## PLAN REVIEW SHEET

**Petition:** 2011-072

### I. SUMMARY REMARKS:

**WAITING PAD WITH 5'X15' BOX SHELTER  
WITH PLANTING STRIP**

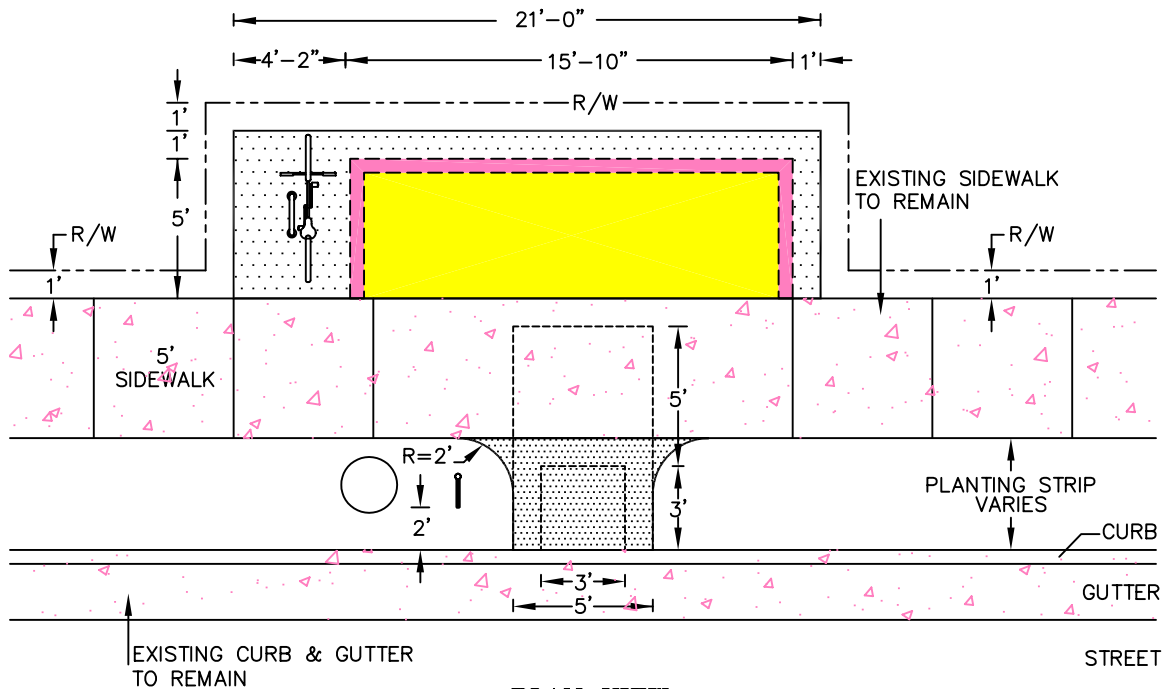
CATS requests that Petitioner install a concrete passenger shelter pad as depicted on the attached. If Petitioner has any questions regarding this request, please contact Ramond Robinson at CATS Service Development, 704.353-0018. Thank you.
